Access Compliance Report

Public Rights-of-Way

Intersection ID: 10019556	Main Street: ALMA_BLOUNT_BV	Cross Street: N/A	Location: SW
ADA ID: A6F92B944FC0	Ramp Type: PerpDiag	Initial Pass/Fail: Pass	Overall Compliance: No
Severity Score: 10			
Codes/Mitigation Info/Possible Solution		Field Measurements/Component Compliance

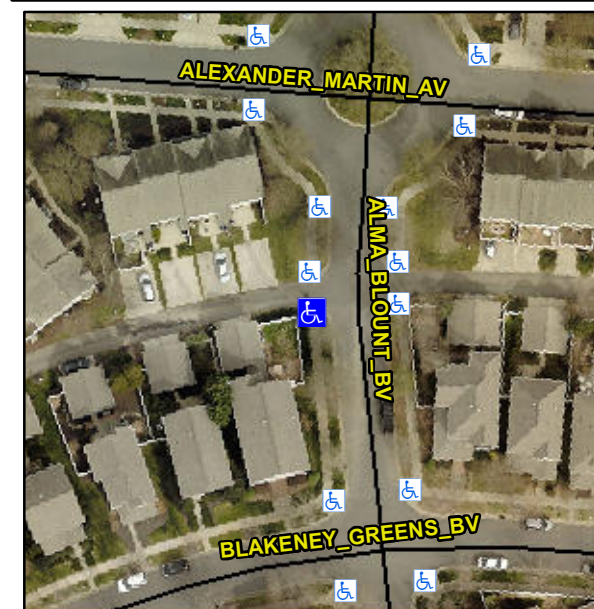
Remove & Replace Curb Ramp With Two New Directional Ramps or Equivalent.

R304.2.2-Perp, R304.3.2-Para, R305
